EAST TOWER  
1333 M STREET, SE  
WASHINGTON, D.C. 20003

MAY 15, 2025

MODIFICATION TO CONSOLIDATED PUD APPROVED IN ZC ORDER 20-06

PROJECT DESCRIPTION  
PHASE 1 OF A 2-PHASE PROJECT  
496 UNITS; 1 RESIDENTIAL BUILDING WITH  
GROUND LEVEL RETAIL

NORTH ELEVATION  
1333 M STREET SE

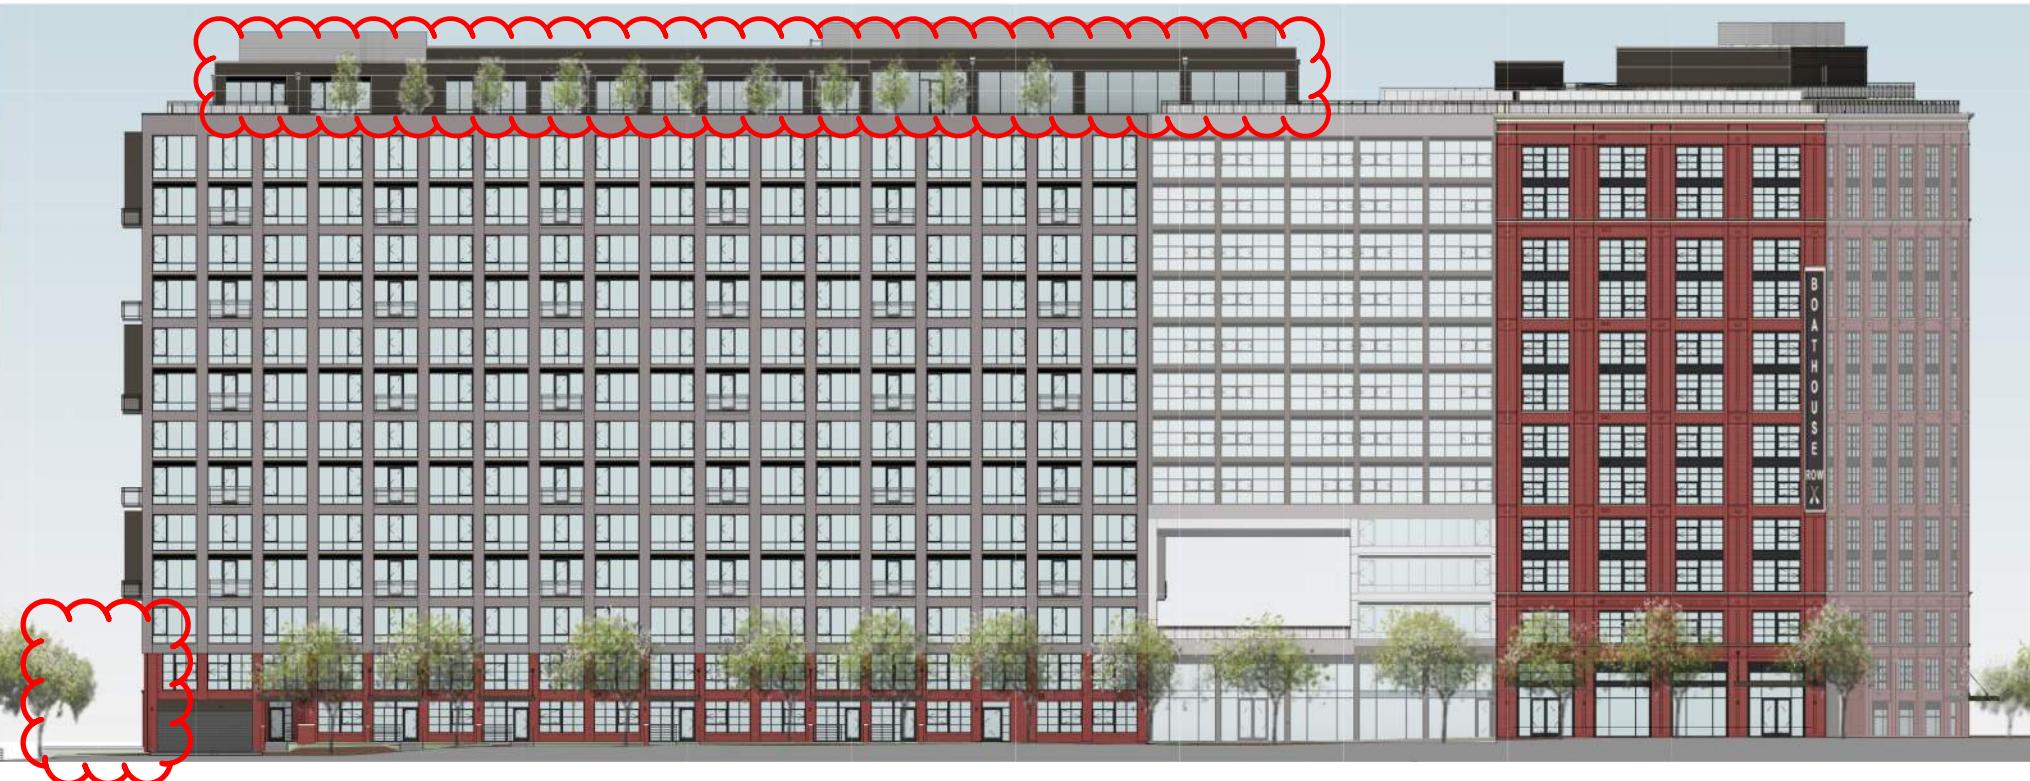
PROPOSED MODIFICATION: The penthouse windows have been adjusted to work with building program and coordinate with fenestration patterns below. On the east side the catwalk as been removed.

SOUTH ELEVATION  
1333 M STREET SE

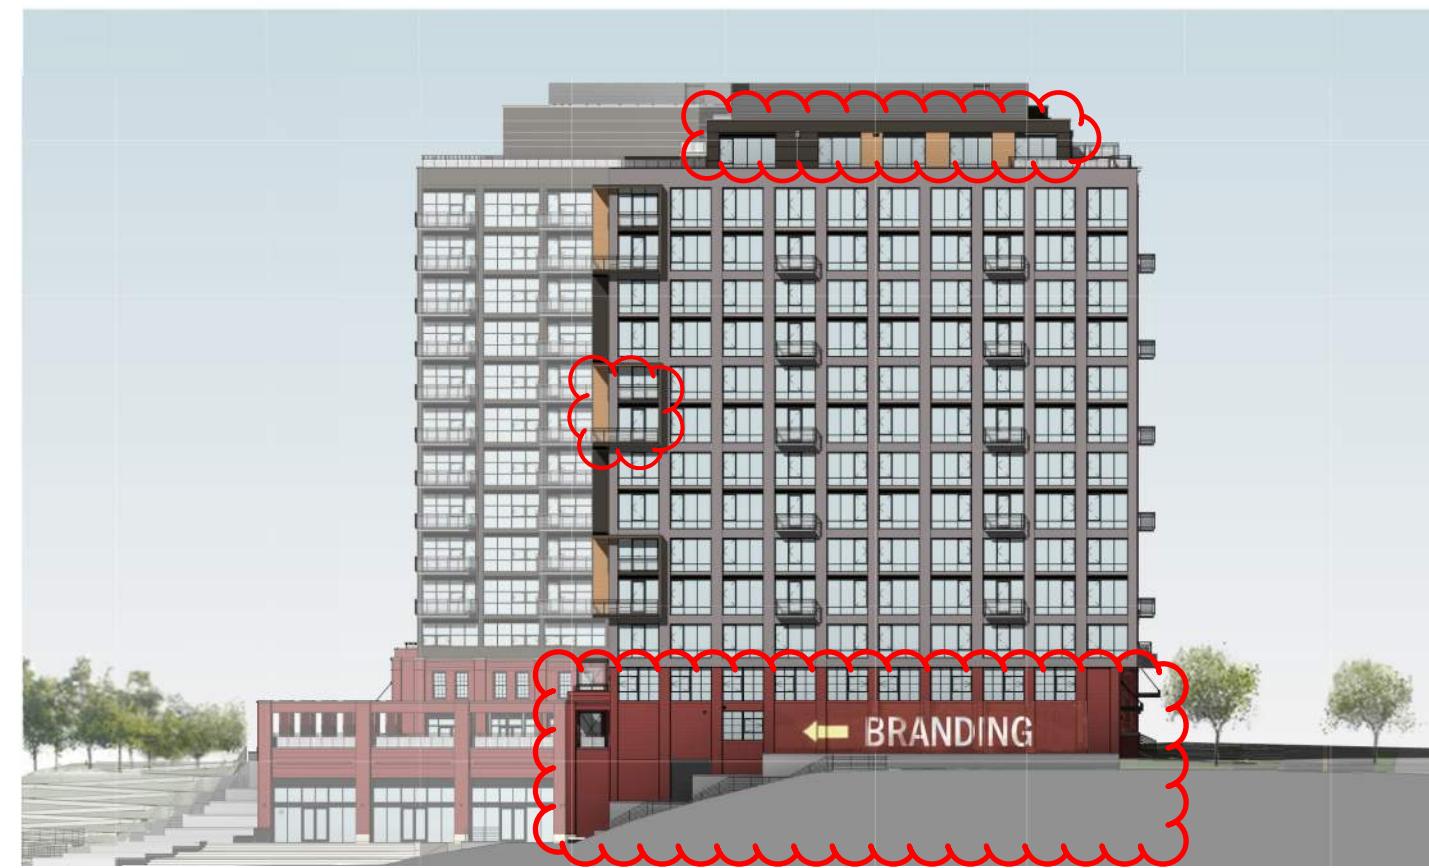
PROPOSED MODIFICATION: The penthouse windows have been adjusted to the updated facade. The catwalk as been removed and in its place is a set of stairs on grade. Enclosed balconies have been changed from glass to metal mesh.
